White Paper

Prepared For: CalAg Aggregator LLC

From: Victoria Evans, Ariane Burwell, Rick Shih and
Jennifer Marchek, ERM

Subject: White Paper: Review of ARB Compliance Offset
Protocol Development: Rice Management Practices

Figure 2. Boxplots showing GHG emissions (tCO₂e/acre) for each county and scenario with scenarios B and H corrected for offsite emissions.

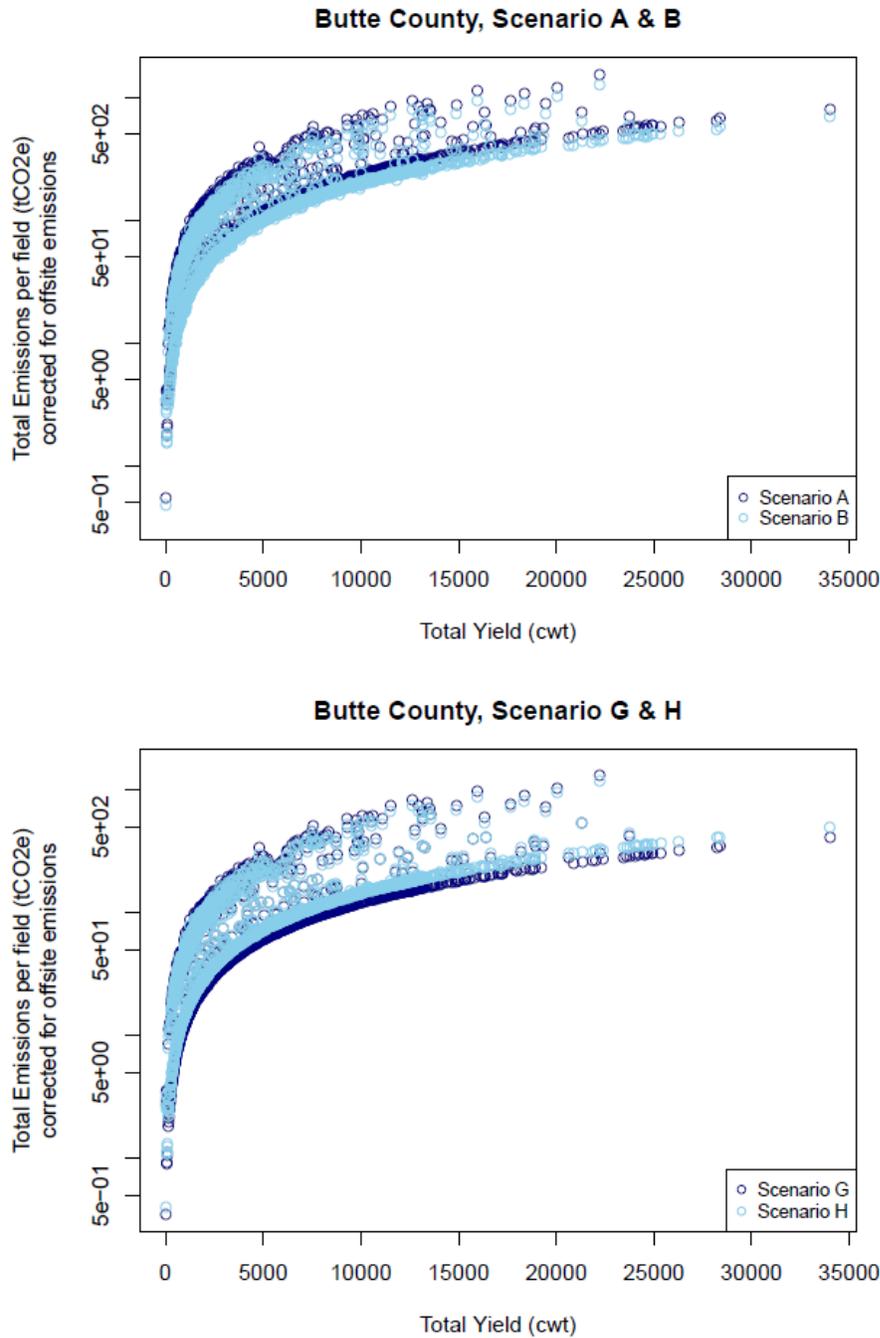
Boxplots of greenhouse gas emissions (Figure 2) show that for a dataset of this size, there are relatively few potential outliers at the high end of the distribution. Formal outlier tests performed in conjunction with a more detailed investigation of these points should be pursued. This will explain why the outliers differ so markedly from the majority of the data. However, since ERM has an incomplete set of the assumptions from EDF, it is impossible for ERM to identify what factors might be causing the outliers. Therefore, ERM's primary finding is that the large number of outliers are a concern and might suggest underlying problems with the input data or more problematically, the biogeochemical mechanisms of the DNDC model ver. 9.3.

As shown on the boxplots (Figure 2) and bar plots (Figure 5) and summarized in Table 1, GHG emissions from winter flooding scenarios (A and B) are consistently higher than emissions from scenarios that do not include winter flooding (G and H), as expected. Note that Figure 5 indicates that for non-winter flooded scenarios, average offsite emissions if straw is diverted to typical current uses are higher than reincorporation of the straw into the fields (average scenario H emissions [uncorrected] are greater than average scenario G emissions). Use of the straw for MDF reduces the emissions for scenario H (corrected for offsite emissions) to be the same as or slightly lower than scenario G. However, it has been shown that GHG emissions during the growing season are about 50% of the annual output, and may be a greater proportion for non-winter flooded fields (Fitzgerald et al., 2000).

Figure 4a. Scatterplots for Butte County showing emissions per acre (tCO₂e/acre) versus yield per acre (cwt/acre), with scenarios B and H corrected for offsite emissions.

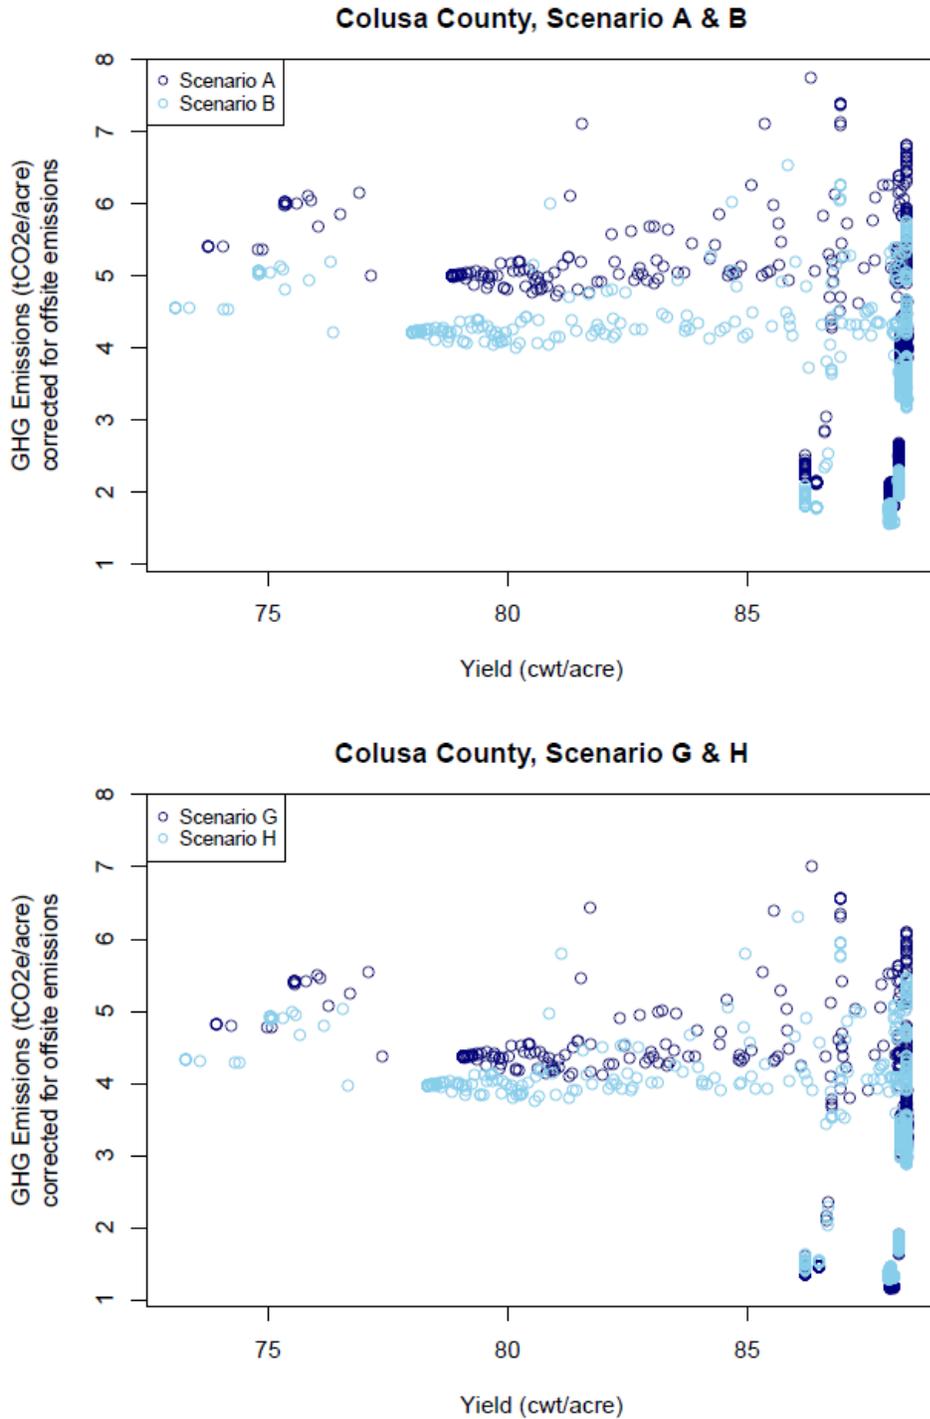
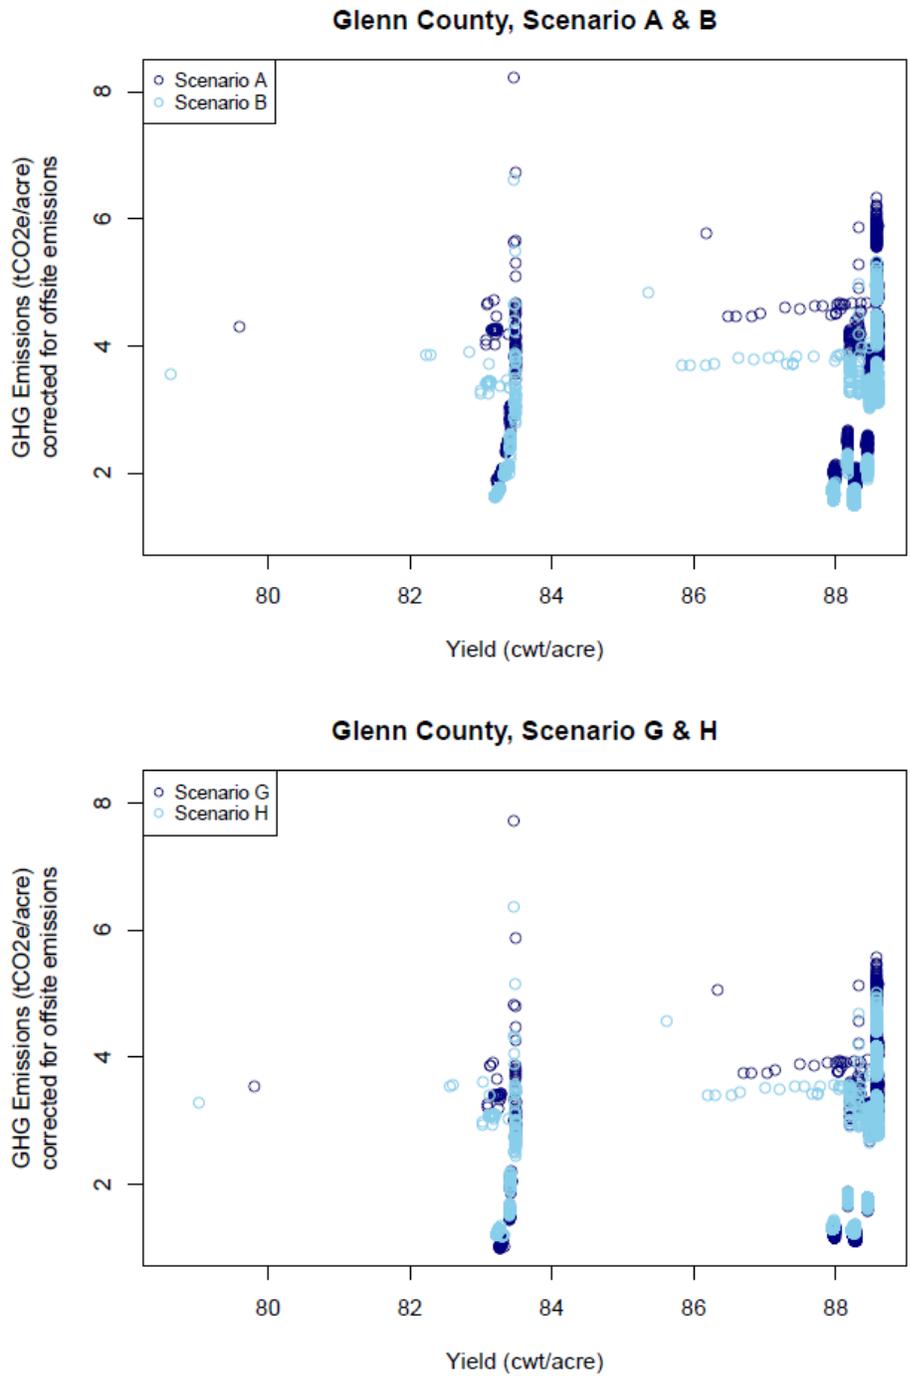
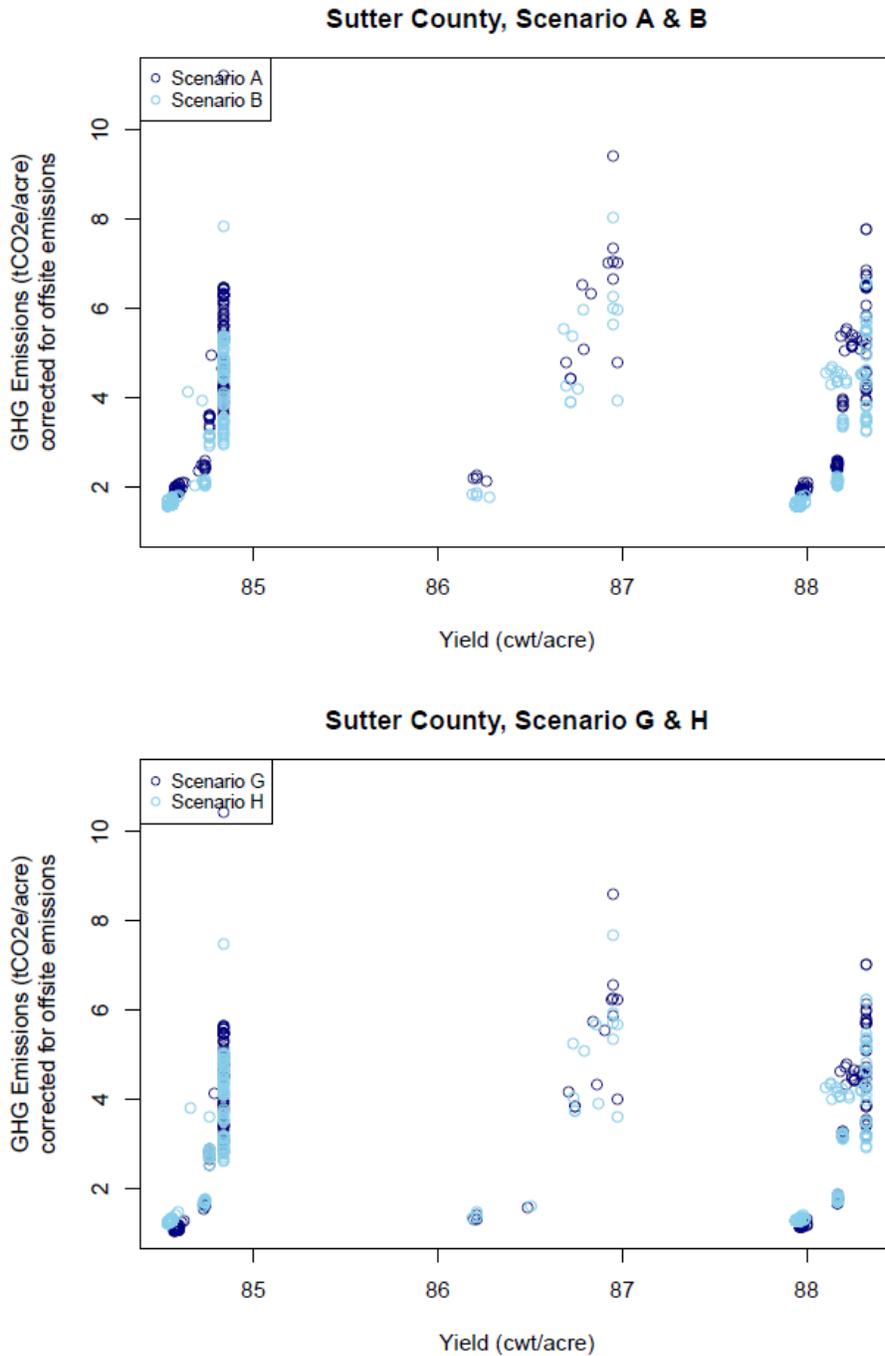
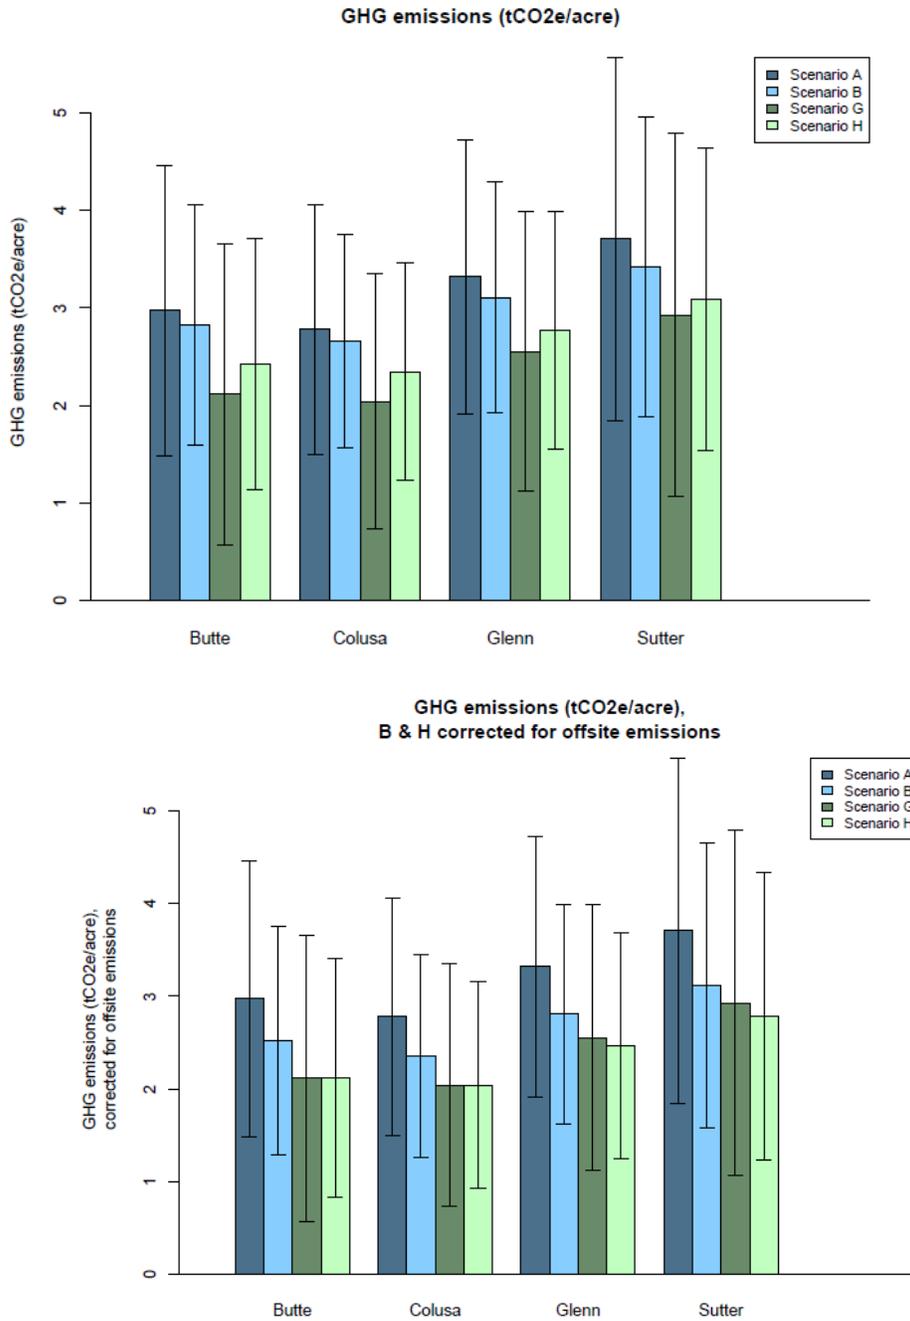
When the relationship between yield and emissions are examined on a per-acre basis, a slightly different pattern emerges. All of the counties show very limited variability in yields. In fact, nearly all of the fields in Butte and Sutter have yields that are approximately 83 cwt/acre, while Colusa and Glenn County fields have average yields of 87 cwt/acre (Figure 6). The possible reasons for these sharp differences in yield are unclear from the data provided. It is unclear why the model output is so consistent for yield; it may be based on a set of assumptions that differ slightly between the two sets of counties for management practices, seasonal effects, or variety of rice planted, or other factors. All counties also have a small number of fields that performed poorly (Figure 4). Colusa County seems to have a higher frequency of poorly performing fields compared to other counties. These plots also show the variation in GHG emissions for a given yield (cwt/acre) within a county.

5. All scenarios show a strong bifurcation in the emissions data. The reasons for the non-linearity in the model output should be explored further.
6. There is little variability in yield/acre; nearly all fields have either 83 or 87 cwt/acre. ERM questions why the model output is so consistent for yield.
7. There is variation among the counties in the distribution of yields and in emissions per acre vs. yield (Figure 4). ERM questions what assumptions are driving this distribution.

Figure 5. Bar plots of mean and standard deviation for GHG emissions (tCO₂e/acre) for each scenario by county combination. The top figure shows B and H without the offsite emissions correction. The bottom figure shows B and H corrected for offsite emissions.

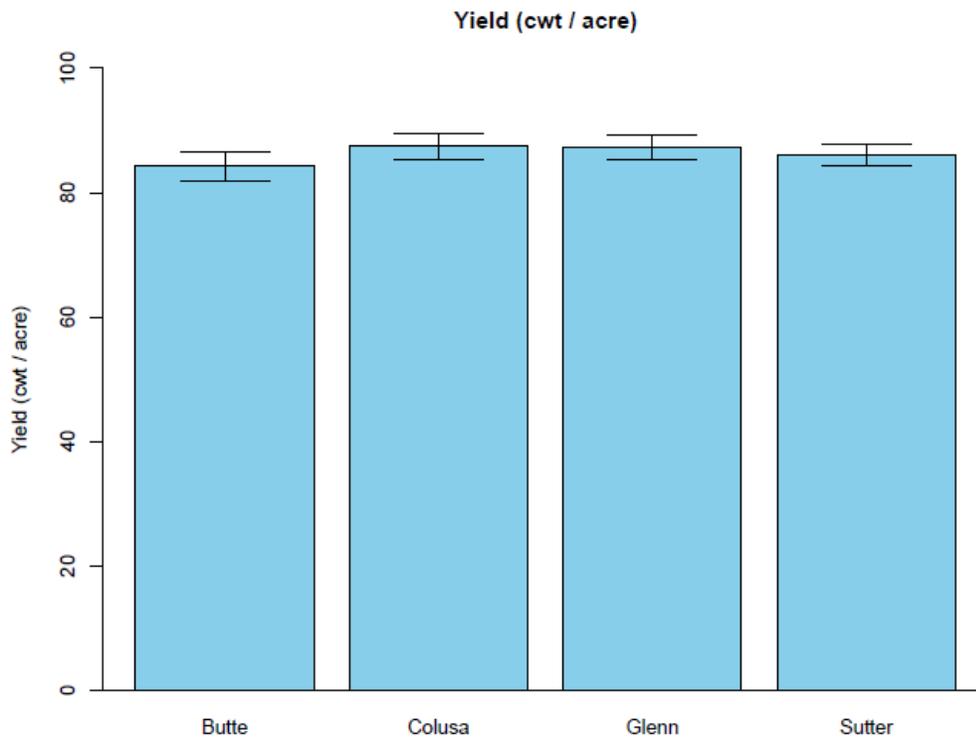
Comparing emissions on a county basis (Table 1 and Figure 5), it is noted that Colusa and Sutter Counties have significantly higher total emissions than Butte and Glenn Counties. Rice acreage in Colusa is 33% higher than Butte, but total emissions are about 41 to 59% higher in Colusa than in Butte, depending on the scenario. In addition, Sutter County has about the same rice acreage as Butte, but has 37 to 73% higher emissions than Butte, depending on the scenario. ERM notes that the source of this variability between counties is unknown.
